MCWF Type-C Machined Features Update

D. Williamson, ORNL January 18, 2005

MTM Review Summary

TF Structure Interface

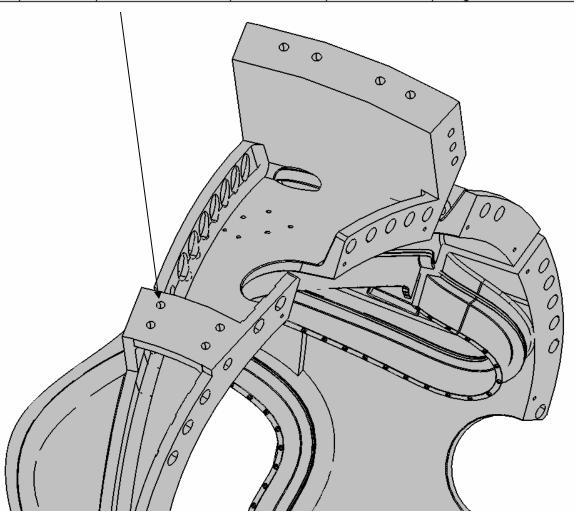
ltem	Α	В	С	Sheet/ Zone	Drawing	CAD Model	Status	Project Response
	Count	Count	Count					
2	16		8	3	Ø.875 TAP DRILL	Ø1.0	OK Ref tap drill Ø	Drawing is correct. Model hole size will be
					1-8 TAP			changed to 0.875-in diameter.

Vessel Support Interface

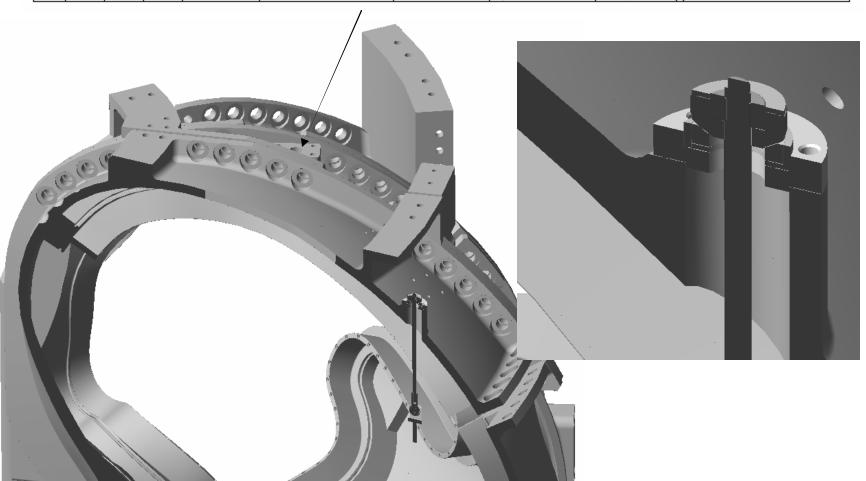
Item	Α	В	С	Sheet/ Zone	Drawing	CAD Model	Status	Project Response
	Count	Count	Count					
-		2		3 F2	Ø1.48 X 5 Thru (5.0 DP)	Ø1.5	open	Change to 2.5-in dia thru, like Drw -114,
3		**		=	Ø1.86 X 2.5 DP CBORE	Ø1.875	open	Sht3, D2. Tapped holes next revision.

TF Structure Interface

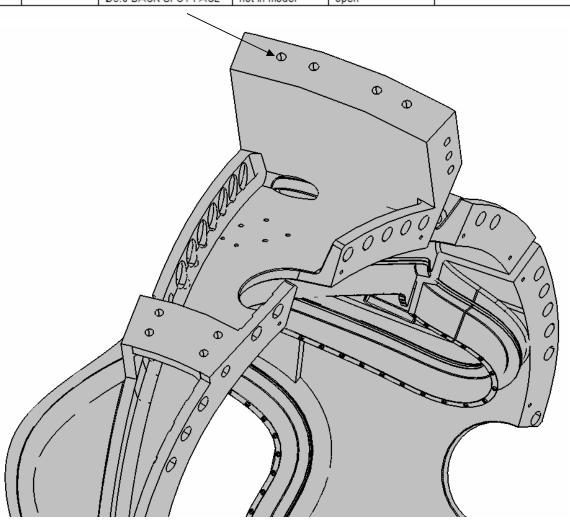
Item	Α	В	С	Sheet/ Zone	Drawing	CAD Model	Status	Project Response
	Count	Count	Count					
6			8	3	Ø1.125			Drawing callout is correct.
					Ø3.0 BACK SPOT FACE	not in model	open	Drawing canout is correct.

Flange A-A (symmetry about midplane)

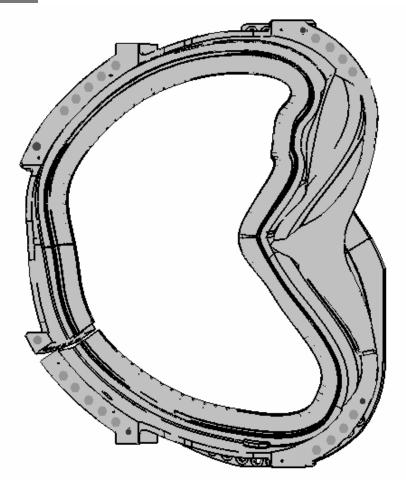
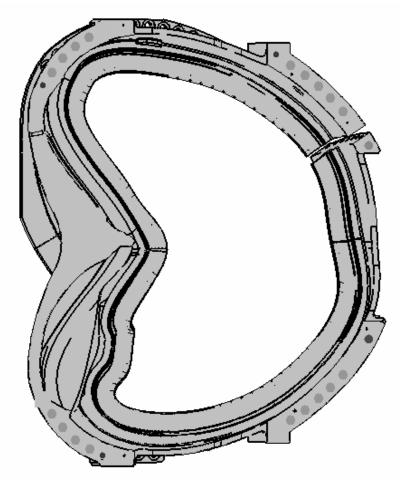
- ♠ ◆ ◆ ♠ ♠ 1.875 DRILL, ♠3.25 BACK SPOT FACE > SAME

Flange A-B

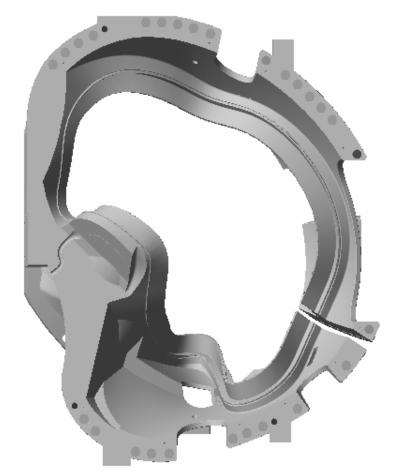
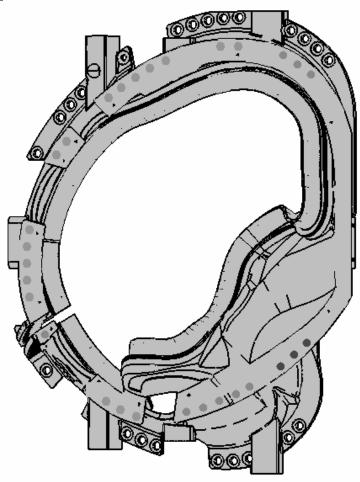
- ◆ ♦ \$3.0 x 1 DP CBORE, \$1.5 x 1.5 DP / THRU > SPHERICAL .75R

Flange B-C

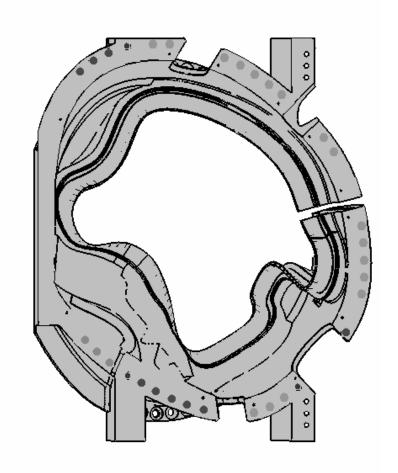
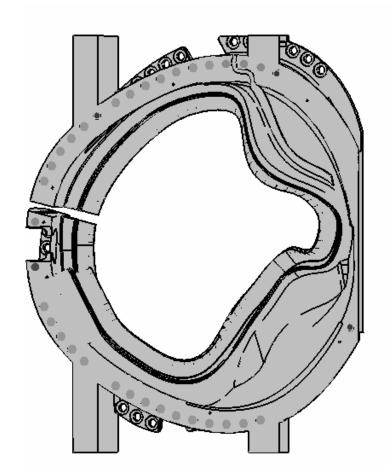
- ♠ ★ ♠ ♠ ♠1.875 DRILL, ♠3.25 BACK SPOT FACE > SAME
- ◆ → \$\phi\$1.375-6UNC THRU > \$\phi\$1.875 DRILL, \$\phi\$3.0 BACK SPOT FACE

Flange C-C (symmetry about midplane)

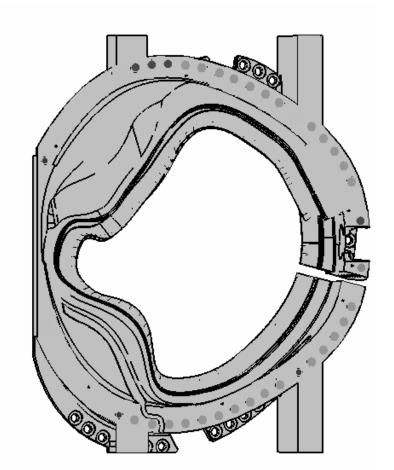
- ♠ ◆ ◆ ♠ ♠ ↑1.875 DRILL, ♦3.25 BACK SPOT FACE > SAME.
- ◆ → \$\phi\$1.375-6UNC THRU > \$\phi\$1.875 DRILL, \$\phi\$3.0 BACK SPOT FACE

Port Openings and Bolt Spacing

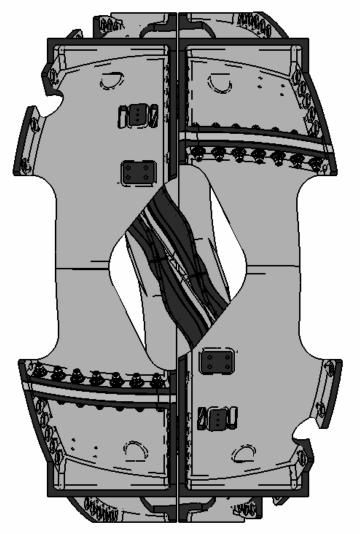
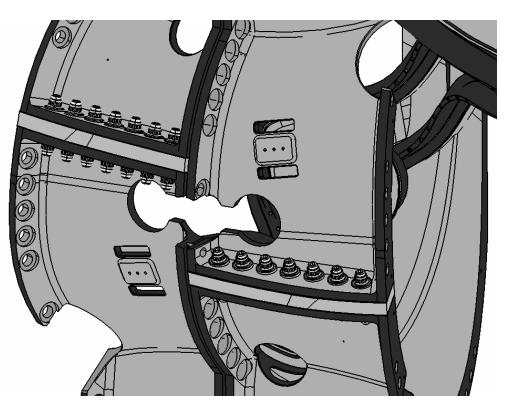
NB port shape required for asm clearance

Counterbore runnout due to bolt spacing

- C-bore dia reduced to 3-in
- Min spot face to reduce depth of cut
- Possible to omit hole (TBD)
